Sent: 31/08/2020 4:54:55 PM
Subject: Application Number DA2020/0816
Attachments: Burn_TPI.pdf;

RE: Application Number DA2020/0816

**DEVELOPMENT APPLICATION DA 2020/0816
23-33 BASSETT STREET MONA VALE
PROPOSED RESIDENTIAL CARE FACILITY UNDER SEPP HOUSING
FOR SENIORS**

Figure 1- North elevation showing west boundary of site and relationship with adjoining cottage style development

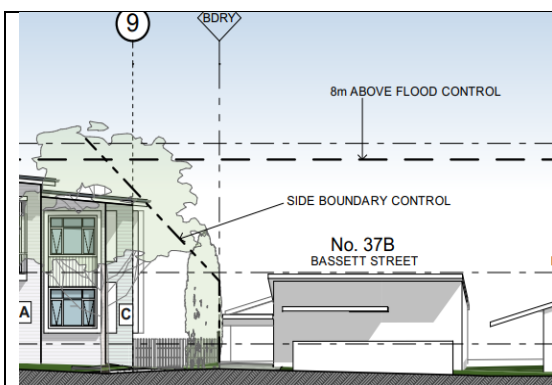
This site is not in a medium density residential zone nor is the property located in a mixed use commercial type environment. The fact that the site is zoned for 'low density residential' purposes should be instructive to the applicant as far as the development proposal is concerned. This is especially the case where low density residential extant development is to be replaced by a high density facility (over the eastern part of the land). We contend that the architect has failed to take into account the reasonable expectations of adjoining land owners and occupiers in this regard. Figures 1 and 2 below show the relationship between the proposal and adjoining development to the east and west (source Gartner Trovato Architects). In our opinion the separation between the built elements in Figure 1 is not acceptable.

Figure 2- North elevation showing east boundary of site and relationship with adjoining cottage style development

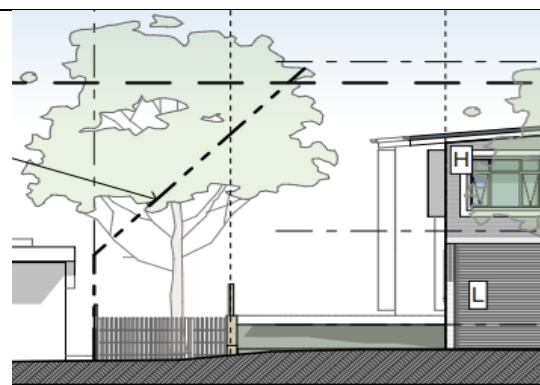
In our view the building should be broken into at least two built elements crossways, so that some respect can be paid to the built form of existing cottages in other parts of this streetscape (with their narrow frontages), the relevant low density zone and the PDCP character statement suggesting that vegetation should be integrated with development. In this case the reduced street setbacks will not allow for sufficient planting to soften this bulky and very lengthy facade.

Below is an extract from the drawings by Gartner Trovato Architects, showing the length of proposed building (around 95m total), when viewed from Bassett Street. The long, unarticulated length of this facade, is completely uncharacteristic of adjoining and nearby development. As Council will be aware the existing building is at odds with the nearby building character. When this bulk is extended for a further distance along Bassett Street, a significant change in the dominant character of the southern side of Bassett Street will result. In our minds this is particularly undesirable.
